# CITY OF ALBUQUERQUE

RE: **Lot 11 Block 8 Unit 22 SAD 228  
6316 Canavio Rd. NW  
Volcano Cliffs Subdivision  
Grading and Drainage Plan  
Engineers Stamp Date 1/20/2022 (D10D003E11)**

## DRAINAGE AND TRANSPORTATION INFORMATION SHEET (REV 6/2018)

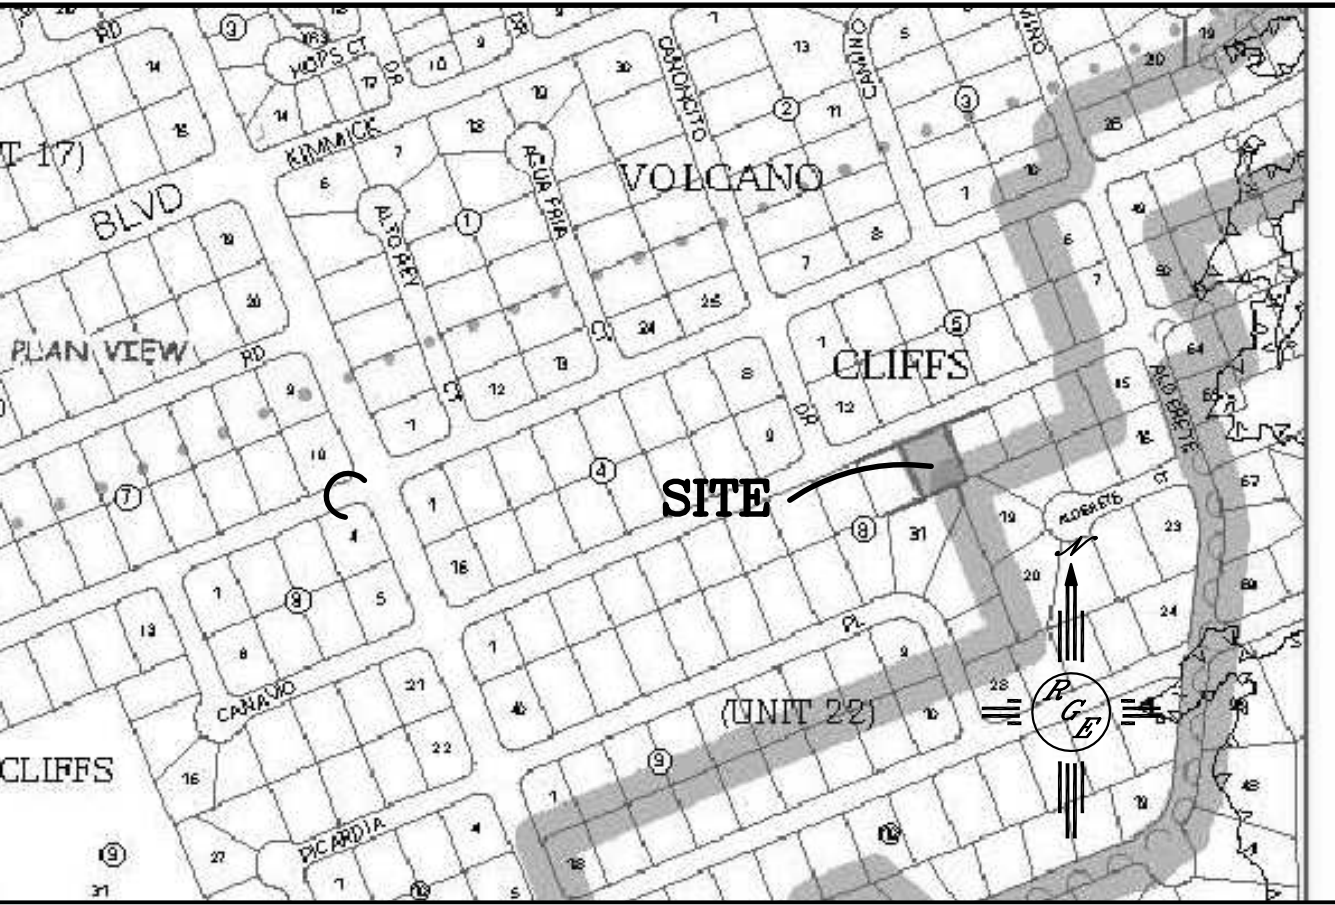
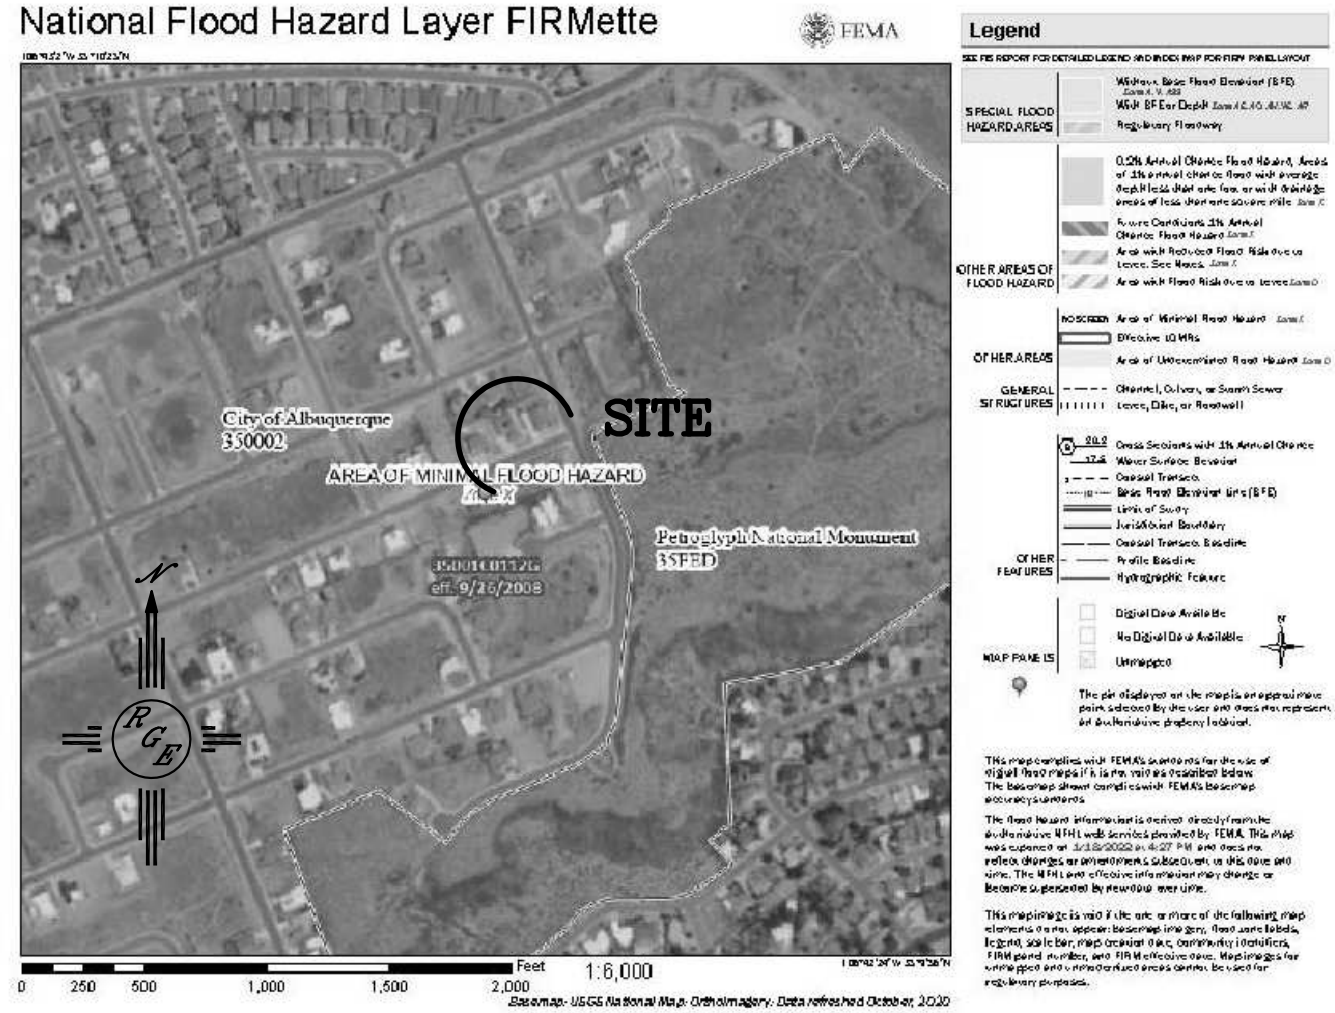
**Advise the owner contractor not to use dirt as a ramp to climb the curb, use lumber or crusher fines for this purpose. Place this comment on the plan.**

**Reiterate to the Owner/Contractor that a separate permit for a garden/retaining wall must be obtained with the approved G&D plan and Pad Certification. Also, if a swimming pool is to be placed after this approval a new grading and drainage plan will need to be resubmitted showing the changes for the land treatments.**

NO EARTHEN RAMPS MAY BE PLACED AT CURB DURING CONSTRUCTION. RAMPS MUST BE ASPHALT MILLINGS OR WOOD
